**City of Lake Elmo  
Planning Commission Meeting  
Minutes of June 8, 2015**

PLANNING COMMISSION  
DATE: 6/22/15  
AGENDA ITEM: 4A – PUBLIC HEARING  
CASE # 2015-19

The City of Lake Elmo has received a request from Lennar Corporation for a preliminary plat for a 46 unit townhouse development tentatively called the Diedrich Property Preliminary Plat. Please note that the original application and all of the construction plans as submitted were for a 48-unit project utilizing a private street. Due to several issues concerning the original configuration of lots and in order to address City, County, and watershed district comments and concerns, the applicant has submitted a revised site plan that now includes a public street and a reduced number of lots. The applicant may still be seeking some variation from City standards in order to plat a public street, and Staff is suggesting that any variations from the City’s zoning and subdivision regulations be addressed at the final plat stage.

Re: Diedrich Property – Preliminary Plan Review

TYPICAL 28' PRIVATE STREET

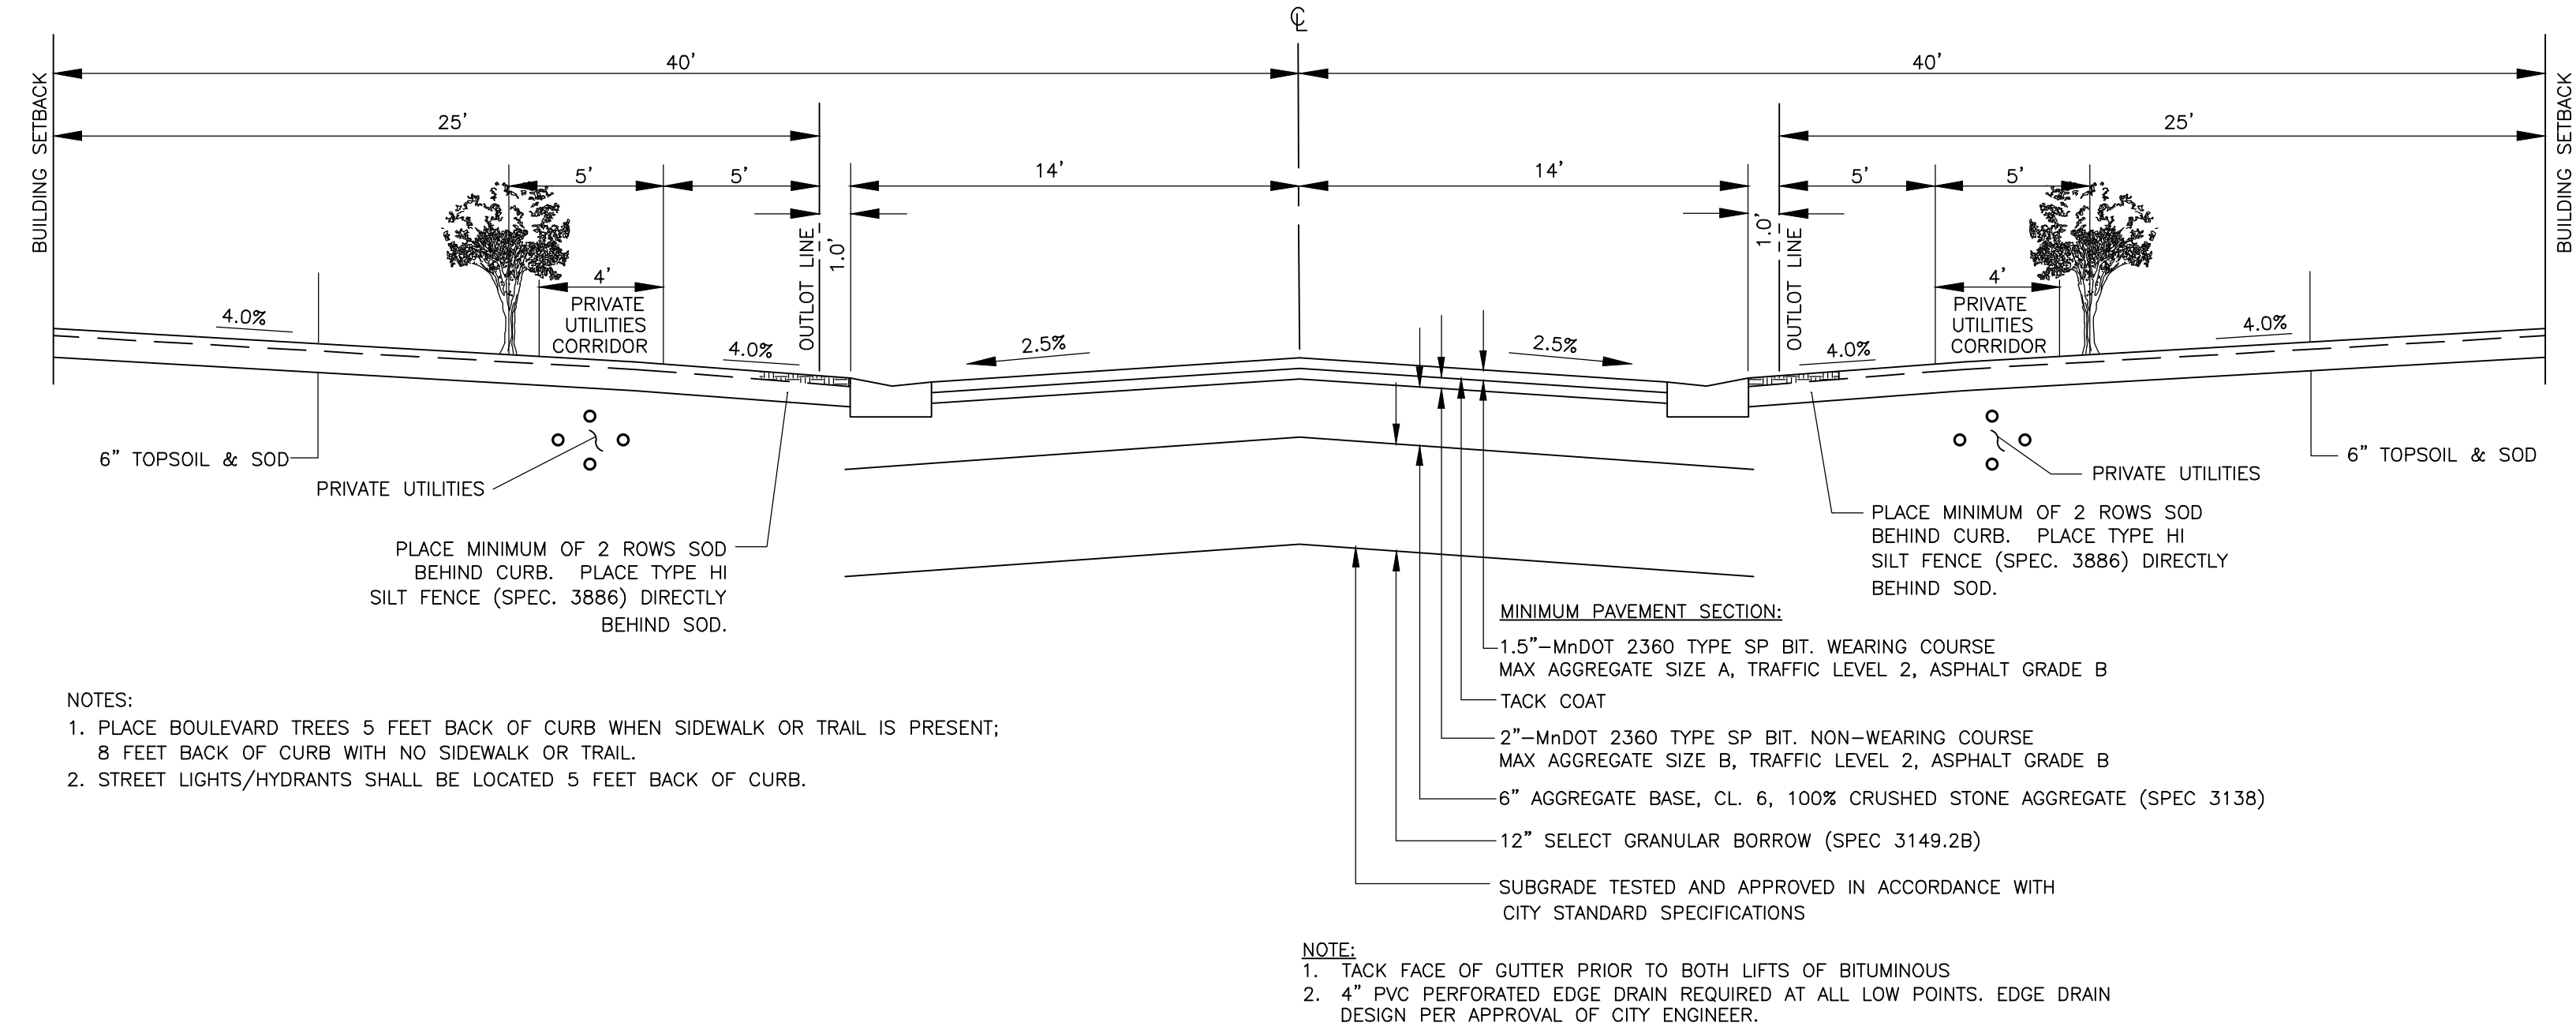
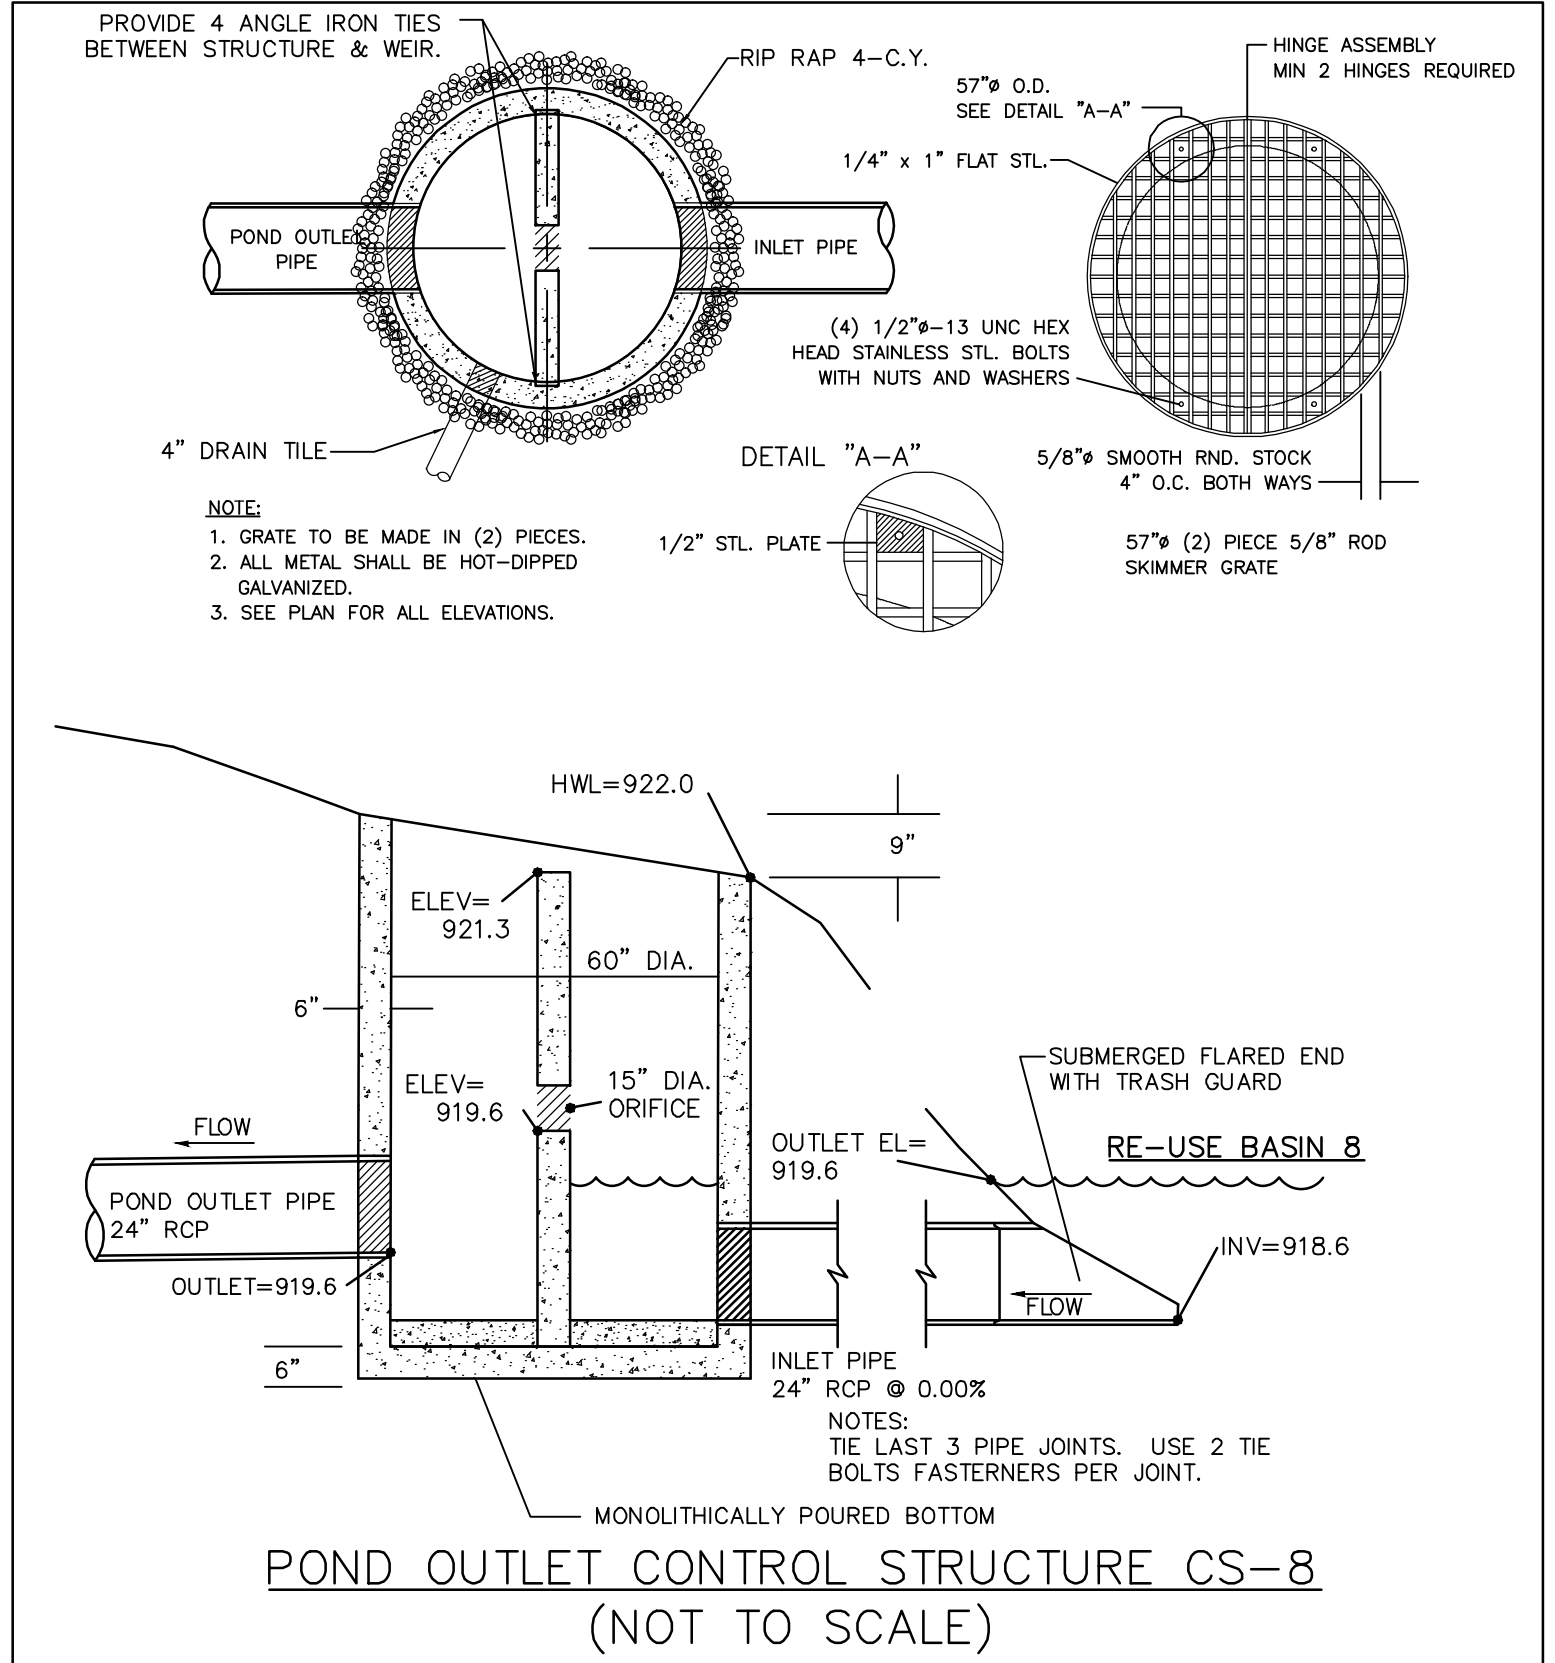
As noted in the preceding section, the developer has submitted an updated site plan that retains the same general layout, and configuration of lots, but changes the proposed private street outlot of 30 feet to a public right-of-way 60 feet in width. The additional right-of-way has been requested by the City Engineer to help ensure that there is adequate room for future maintenance and upkeep of public utilities (sewer, water, and other private utilities) within this subdivision. All final construction plans will need to be updated to reflect the public right-of-way and reconfiguration of lots.

- 9) The applicant shall update all of the landscaping and construction plans to reflect the updated site plan that includes a public right-of-way within the project area. These updated plan shall be subject to review and approval by the City Engineer.

- 14) The site plan and construction plans shall be revised to include a sidewalk along at least one side of all streets within the subdivision.
